Project: San Angelo ISD Paging Upgrade (RFP #26-008)

Subject: Addendum 01

TECHNOLOGY ITEMS FOR ADDENDUM 01

FLOOR PLAN - CENTRAL
HS - BUILDING N - TWAIN

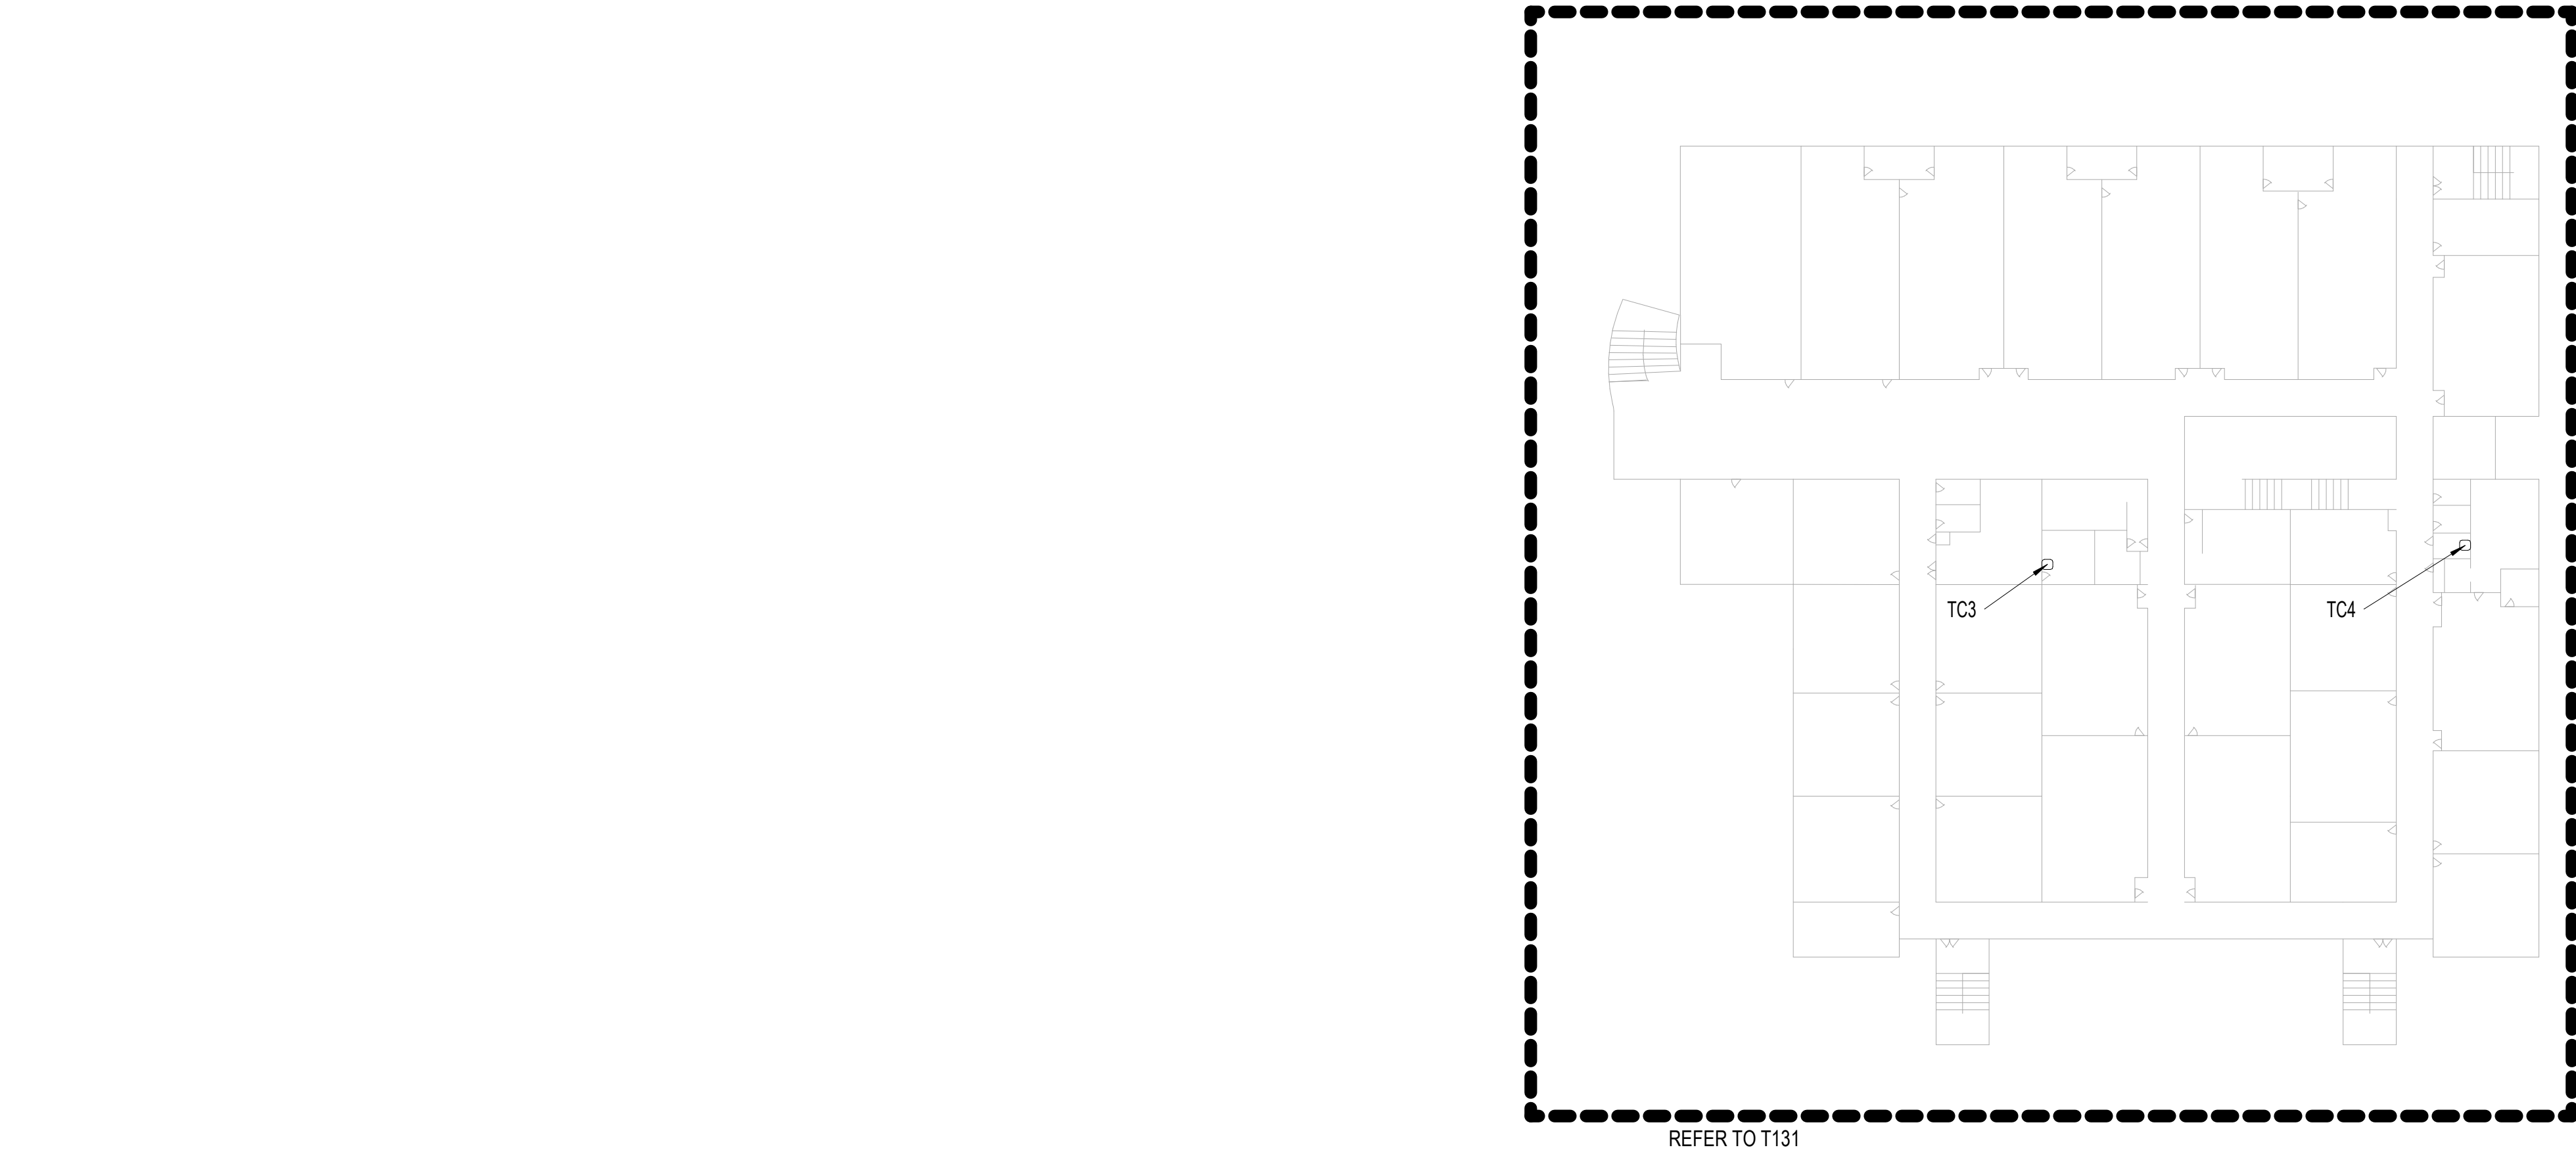
ADD No 1, Tech. Item 16: To the Drawings, Sheet T114, “FLOOR PLAN - CENTRAL HS - BUILDING N - TWAIN,”

- 1) Added halftone speaker clarification to Sheet Notes.
- 2) Added paint/finish clarification to Sheet Notes.
- 3) Clarified high-ceiling lift requirement item in Sheet Notes.
- 4) Modified/consolidated Keynote 16/17.

FLOOR PLAN - LAKE VIEW
HS - FIRST FLOOR -
BUILDING A - AREA C

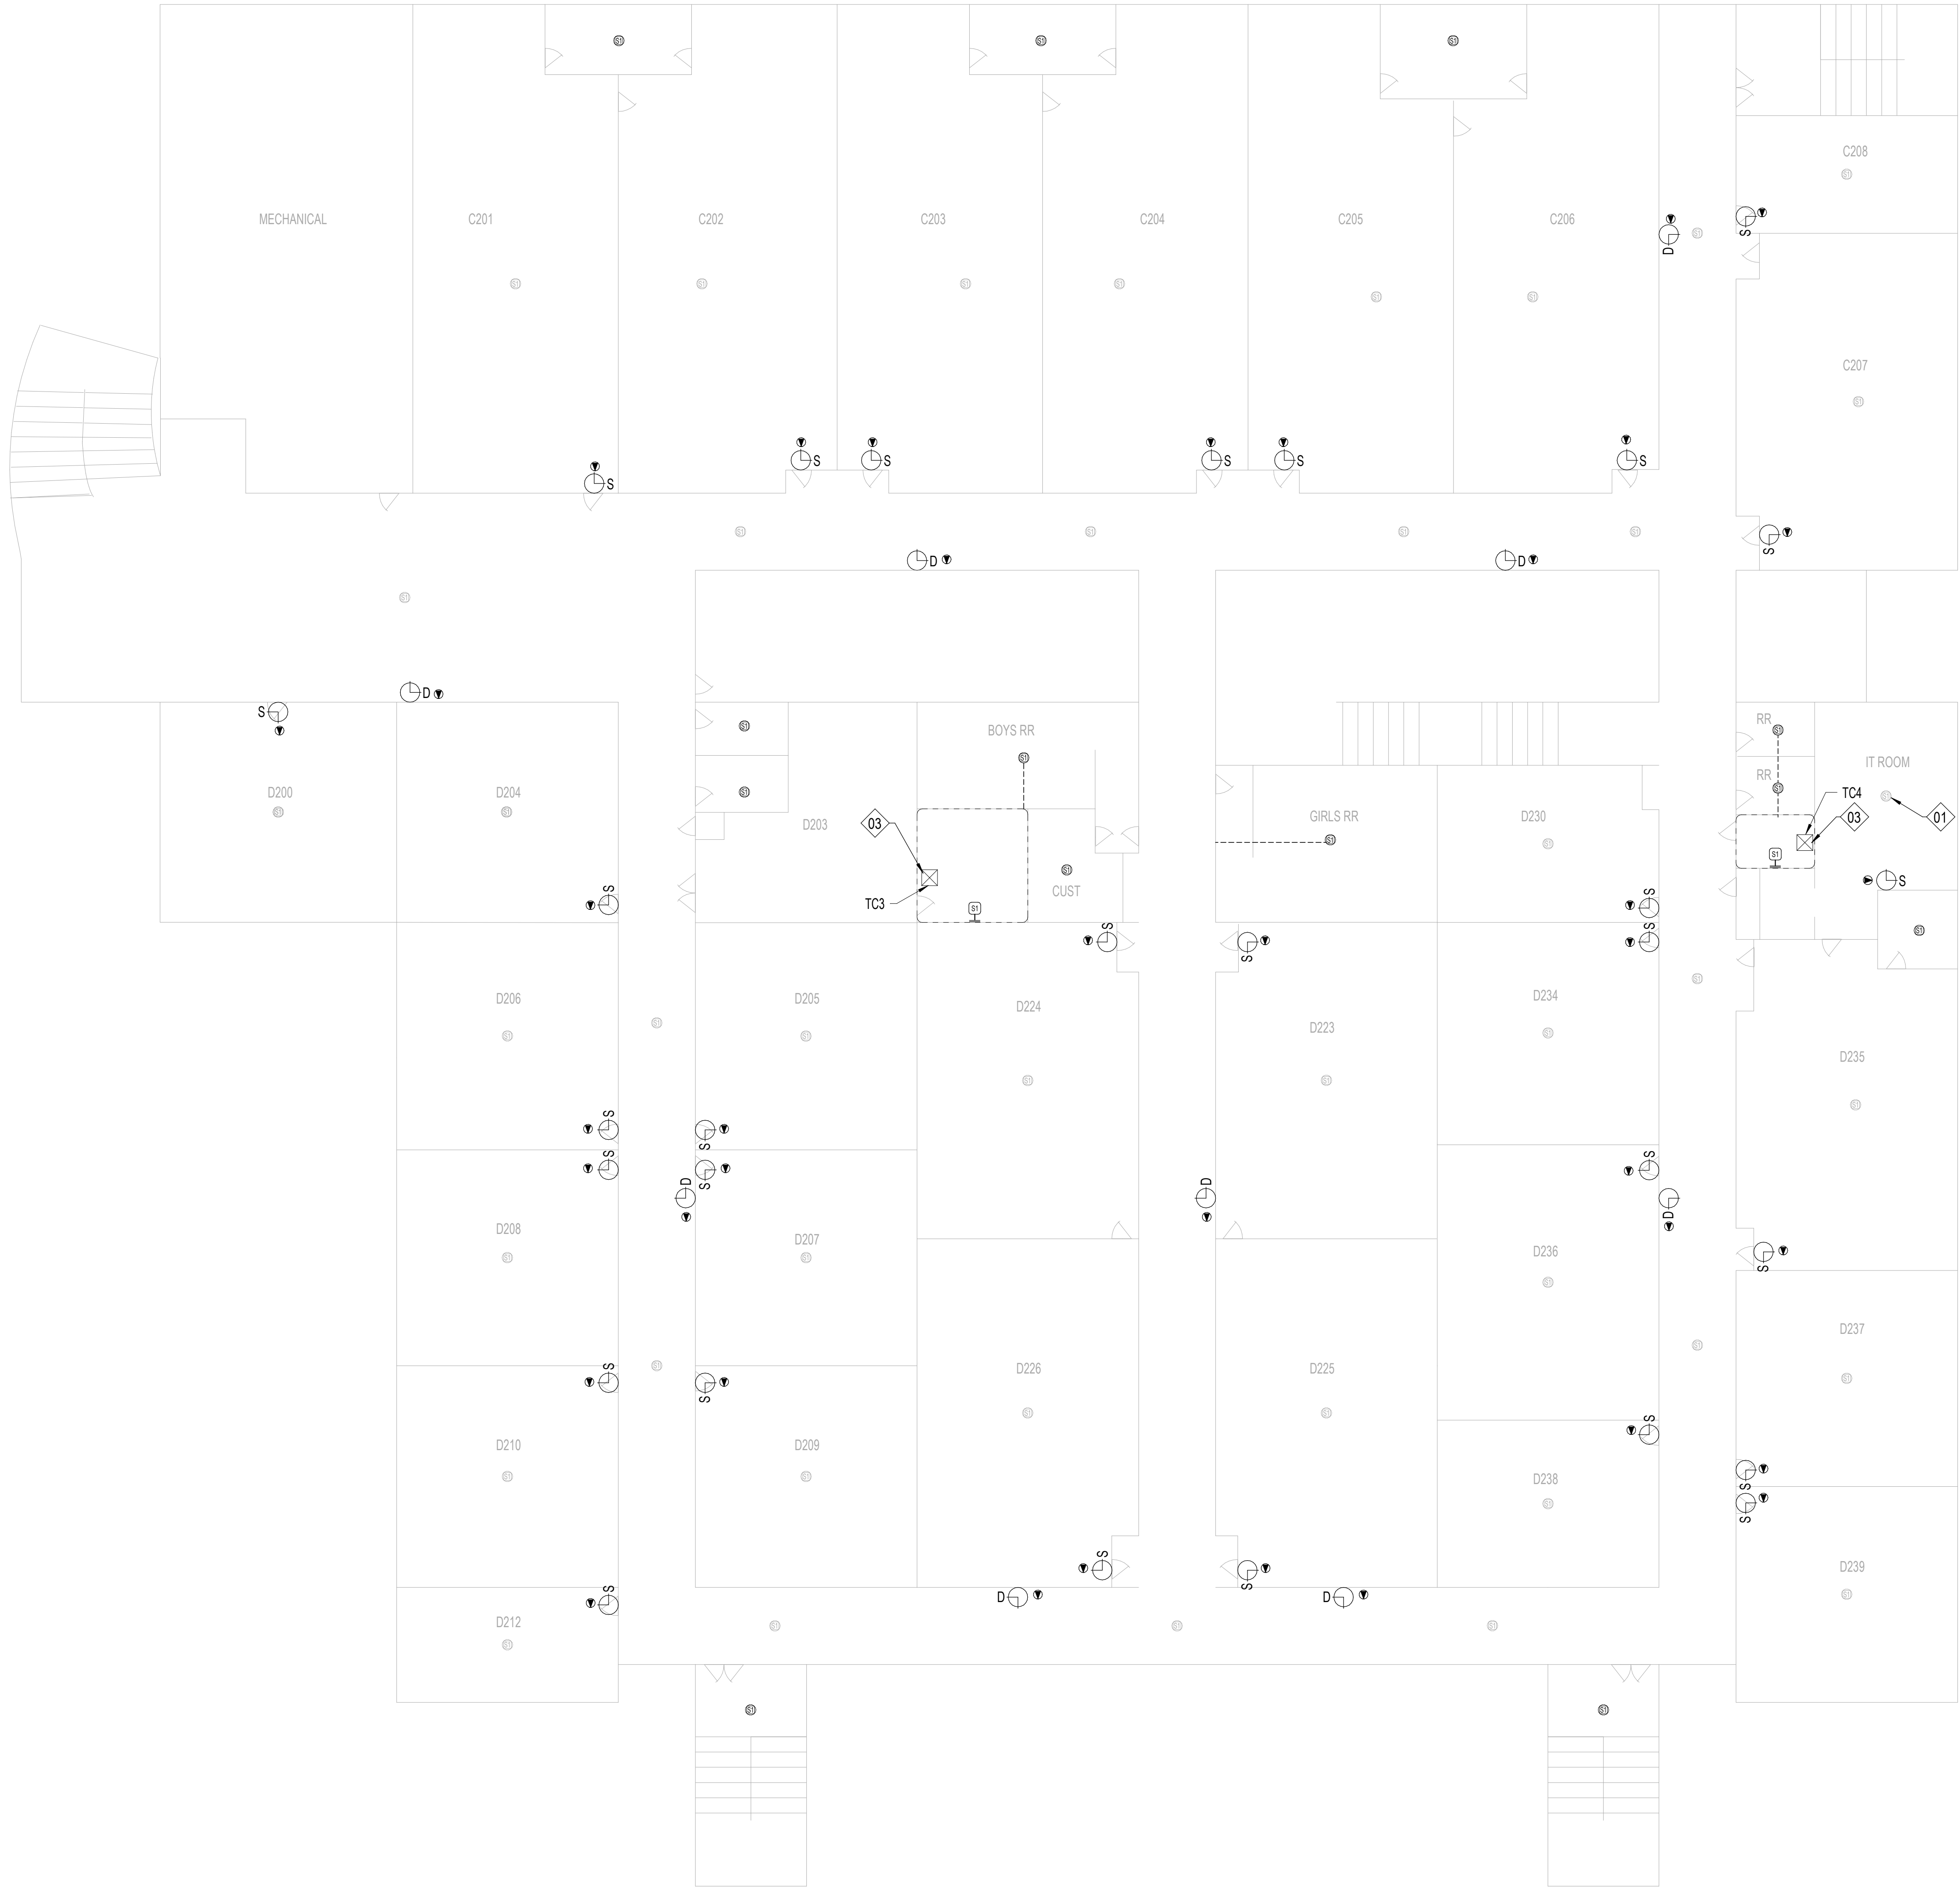
ADD No 1, Tech. Item 19: To the Drawings, Sheet T118, “FLOOR PLAN - LAKE VIEW HS - FIRST FLOOR - BUILDING A - AREA C,”

- 1) Added halftone speaker clarification to Sheet Notes.
- 2) Added paint/finish clarification to Sheet Notes.
- 3) Clarified high-ceiling lift requirement item in Sheet Notes.
- 4) Modified/consolidated Keynote 16/17.

FLOOR PLAN - LAKE VIEW
HS - SECOND FLOOR -
BUILDING A - AREA C

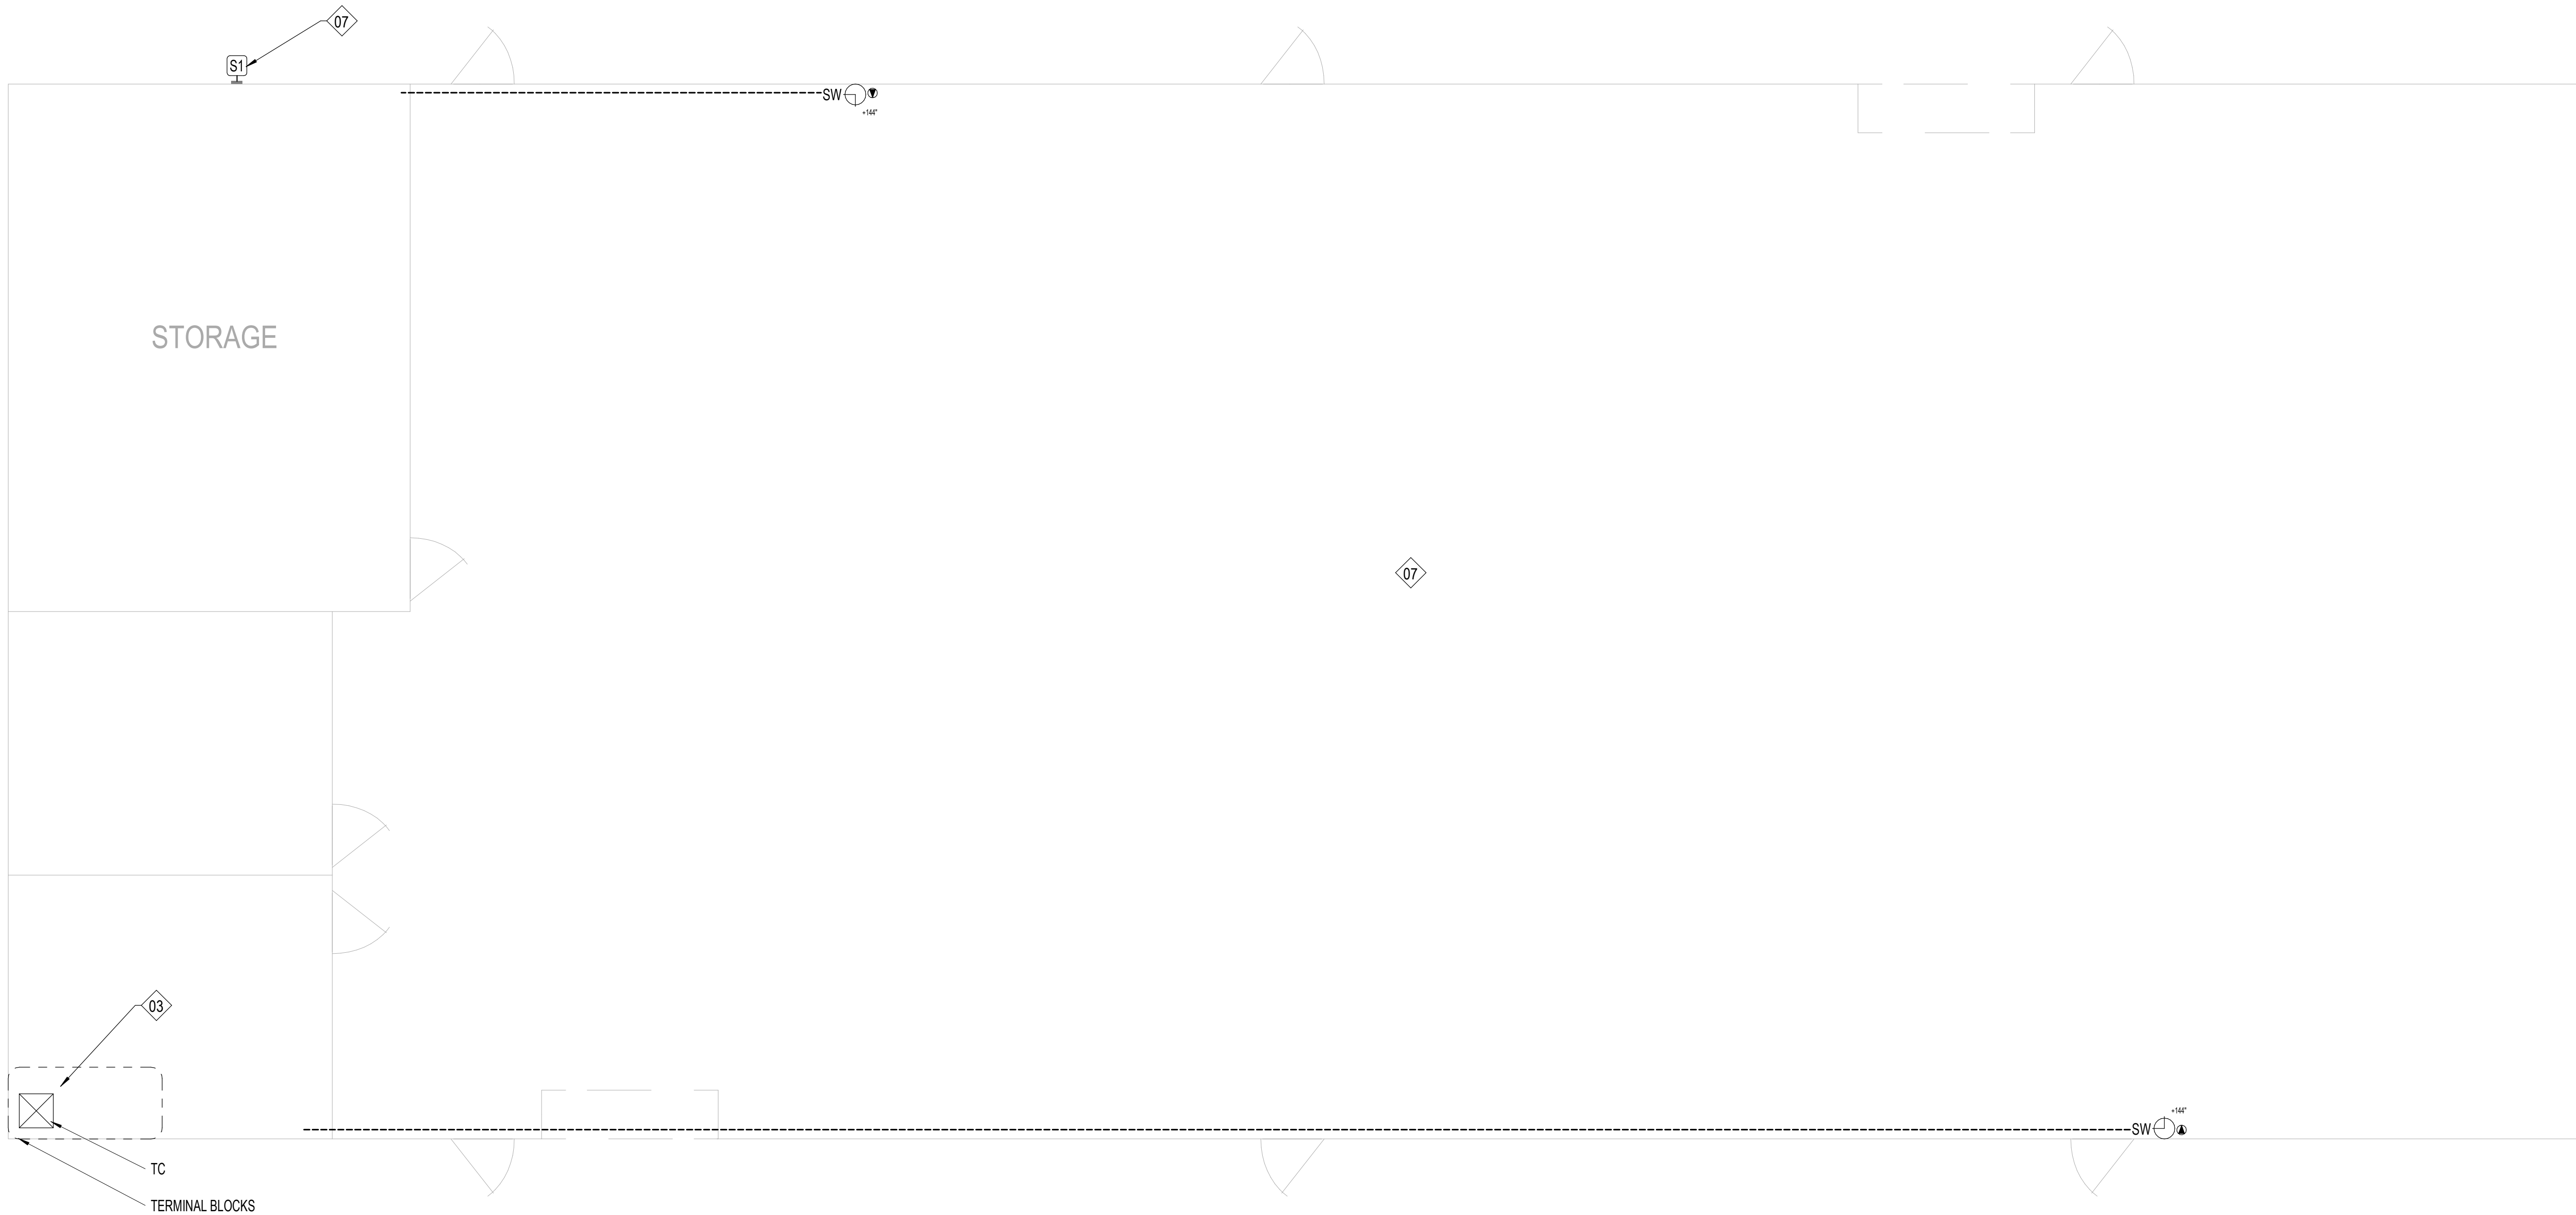
ADD No 1, Tech. Item 20: To the Drawings, Sheet T119, "FLOOR PLAN - LAKE VIEW HS - SECOND FLOOR - BUILDING A - AREA C,"

- 1) Added halftone speaker clarification to Sheet Notes.
- 2) Added paint/finish clarification to Sheet Notes.
- 3) Clarified high-ceiling lift requirement item in Sheet Notes.
- 4) Modified/consolidated Keynote 16/17.

1 FLOOR PLAN - LAKE VIEW HS - BUILDING C
T120 1/8" = 1'-0"

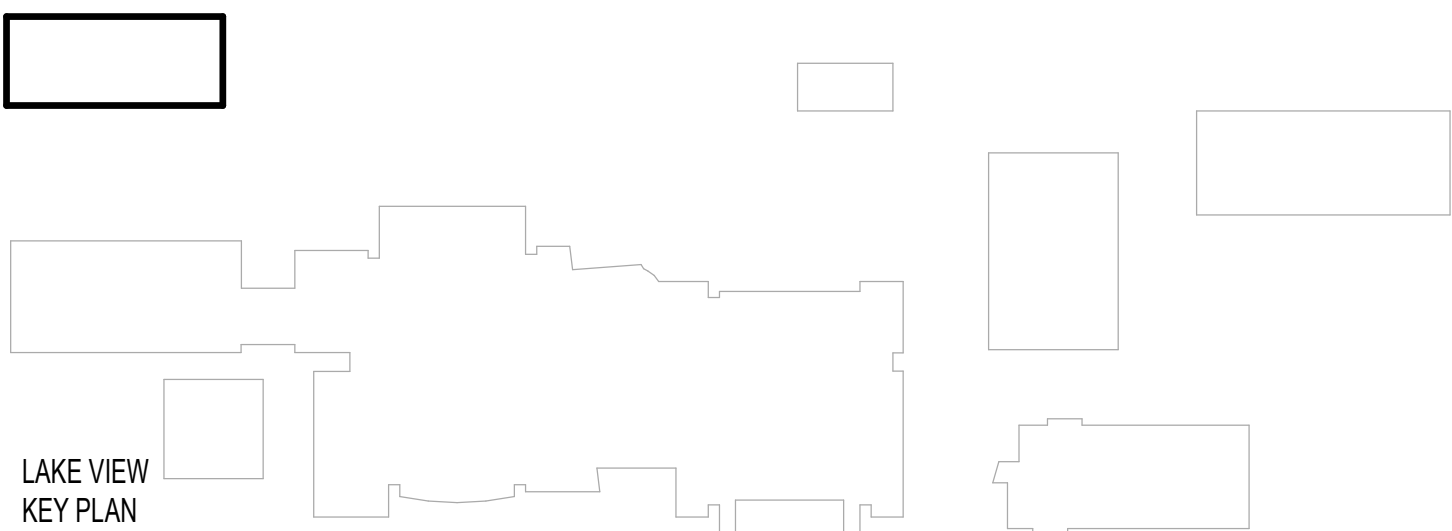
ADD No 1, Tech. Item 21: To the Drawings, Sheet T120, "FLOOR PLAN - LAKE VIEW HS - BUILDING C,"

- 1) Added halftone speaker clarification to Sheet Notes.
- 2) Added paint/finish clarification to Sheet Notes.
- 3) Clarified high-ceiling lift requirement item in Sheet Notes.
- 4) Modified/consolidated Keynote 16/17.
